Video Products Technical Bulletin 30-2001-107R

DATE: **March 24, 2003**SUBJECT: **WHITE VERTICAL LINE NOISE IN BLANKING**

MODEL: **BVM-D24E1WA**
BVM-D24E1WE
BVM-D24E1WU
BVM-D32E1WE
BVM-D32E1WU

Figure 1

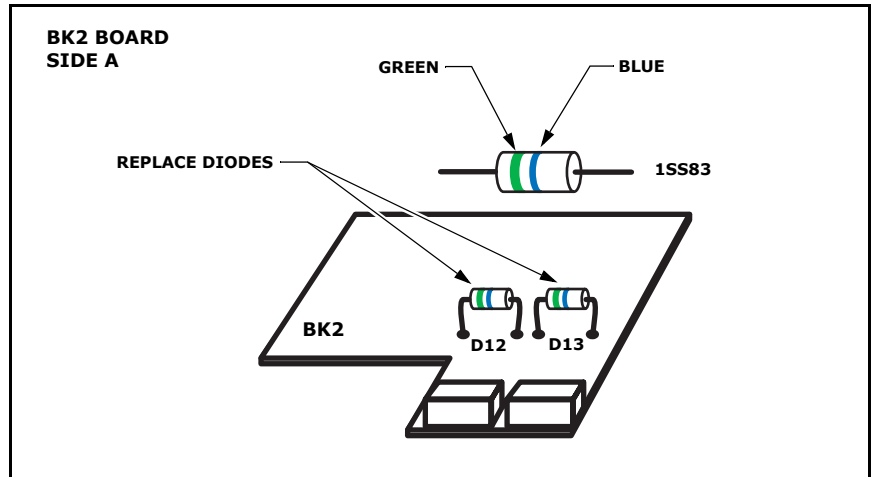
**MODIFICATION PROCEDURE****BK2 Board (Piggyback Board on BK Board)****Side A**

1. Replace D12 and D13 with new 1SS83 diodes. (See Figure 1.)

NOTE: Observe correct polarity.

2. Replace R14 (3.3 kΩ) with a new 10Ω resistor.

Figure 2

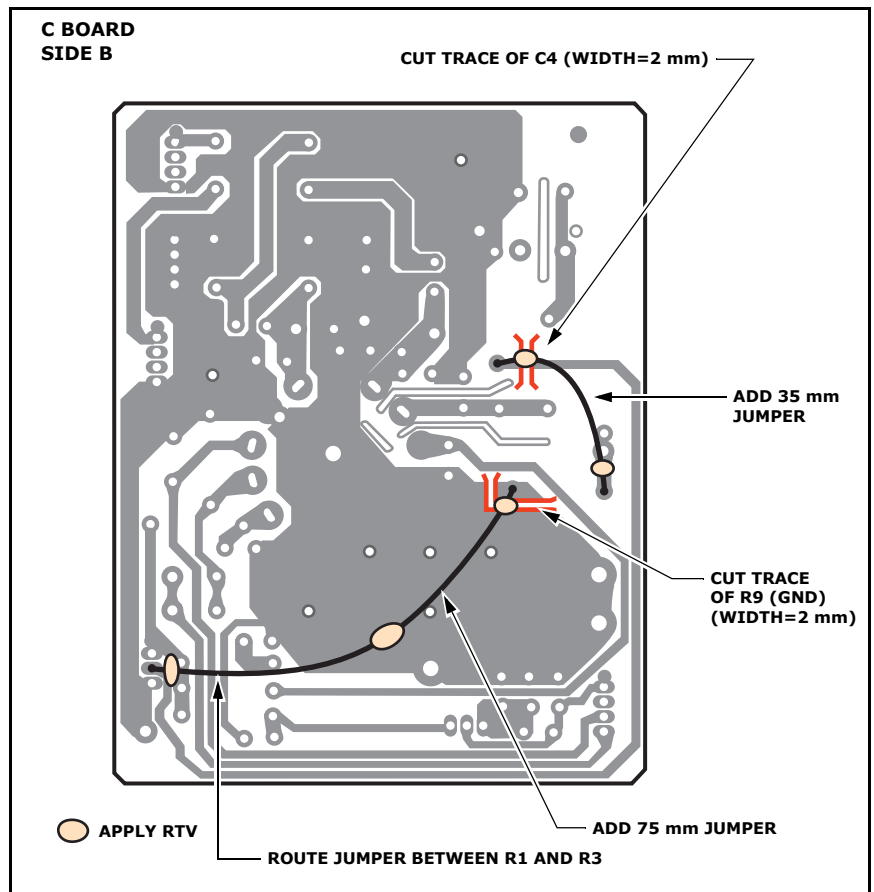
**C Board (Side B)
(See Figure 2.)**

1. Remove CN9.
2. Replace R9 (1 M Ω) with a 1 k Ω resistor.
3. Cut the trace of R9 (GND) as shown in Figure 2.
4. Cut the trace of C4 leading towards CN3 as shown in Figure 2.
5. Solder a 75 mm jumper between CN7 pin 2 and R9.
6. Solder a 35 mm jumper between C4 and R9.
7. Affix jumpers to the board with RTV.
